APPLICATION - CONSULTATION RESPONSE

Consultee:	Landscape
Reference Number:	23/03204/OUT
Proposal:	Outline application (with all matters reserved) for the demolition of existing buildings and structures and redevelopment of the site for a new local centre (E (a-f), F1(b-f), F2(b,d)), open space and employment (office and laboratory) floorspace (E(g)(i)(ii) to the ground floor and employment floorspace (office and laboratory) (E(g)(i)(ii) to the upper floors, along with supporting infrastructure, including pedestrian and cycle routes, vehicular access, car and cycle parking, servicing areas, landscaping and utilities. (The Development is the subject of an Environmental Impact Assessment)
Site Address:	Beehive Centre Coldhams Lane Cambridge
Case Officer:	Cuma Ahmet
Responding Officer:	Bana Elzein
Date:	28 Nov 2023

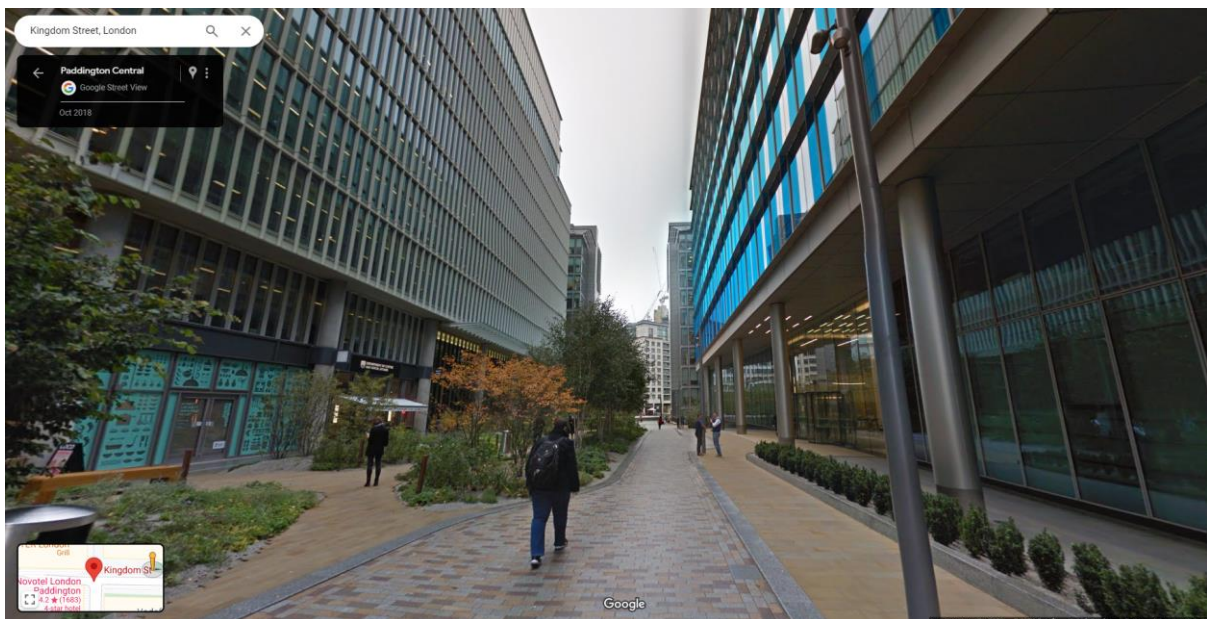
Garden Square is the most central of the open spaces intended to be the main gathering and open space for the use of workers on the site as well as visitors. Proportionally, the size of this space, dominated by water/wetland planting, provides little useable space which is predominantly pushed to the edges against the buildings and crossed centrally by a vehicular/bus route as well as edged at the southern edge by another vehicular/bus route.

This constrained landscape further limits the ability of the space to provide substantial, large-growing tree species. Large trees are needed to mitigate the losses being incurred across the proposals from the existing condition and also to provide characteristic layering within views of trees within buildings. In addition, Cambridge's tree policies seek to improve canopy provision across the city and large growing species are a key part of achieving that aim.

The open space is further compromised by the scale of the buildings around it making it feel enclosed and overwhelmed in an urban way that is not familiar to Cambridge and not entirely suitable in this location.

It is considered that the scale of this key open space must be increased, should avoid being crossed by vehicular routes and be more generous with dwell spaces.
